# CITY OF FONTANA

## I-15 LOGISTICS

### FINAL ENVIRONMENTAL IMPACT REPORT

SCH No. 2018011008

**Figure 1: South Coast AQMD Staff’s Screenshot of Proposed Project’s Line-Volume Truck Emission Sources in AERMOD**

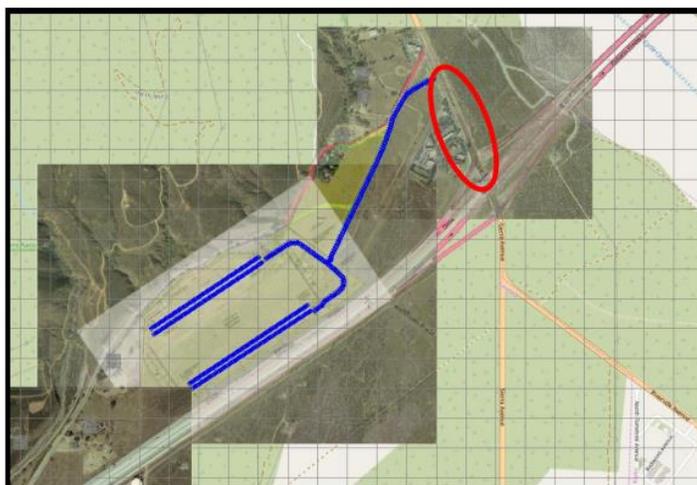
2. The Lead Agency used AERMOD to model the dispersion of the Proposed Project’s emissions and perform a health risk assessment (HRA). In AERMOD, the Lead Agency modeled the dispersion of diesel particulate matter (DPM) emissions from heavy-duty trucks entering and exiting the Proposed Project, onsite travel, and trucks idling at the proposed dock doors. As illustrated in Figure 1, trucks entering and exiting the Proposed Project were modeled as a line-volume source from the Proposed Project’s boundary to Sierra Avenue. However, it is recommended that mobile source emissions resulting from heavy-duty trucks visiting the Proposed Project be modeled to the nearest freeway on-/off-ramp. Therefore, South Coast AQMD staff recommends that the Lead Agency revise the air dispersion modeling to account for trucks traveling to and from the nearest freeway, in this case Interstate 15 (circled in red in Figure 1).

- 3-7 The commenter requests that the dispersion modeling and health risk assessment modeling be updated to include air dispersion modeling to and from the nearest freeway. The air dispersion modeling and health risk assessment (HRA) has been revised to include a line-volume source along Sierra Avenue to the nearest Interstate 15 (I-15) on-/off ramp. This addition allows the modeling to account for trucks traveling to and from the nearest freeway, I-15 in this case. This change is reflected in *I-15 Logistics Center Alternative – Health Risk Assessment Technical Memo* (HRA Memo), prepared by Michael Baker International, dated March 25, 2020; refer to Section 3.0. As concluded on Page 7 of the *I-15 Logistics Center Alternative – Health Risk Assessment Technical Memo* (HRA Memo) non-carcinogenic hazards resulting from the Proposed Project are calculated to be within acceptable limits; refer to Appendix B, of the Final EIR. Additionally, impacts related to cancer risk and PM<sub>10</sub> concentrations from warehouse operations would be less than significant at the nearest residential receptors and for workers. Therefore, impacts related to health risk from warehouse operations would be less than significant.
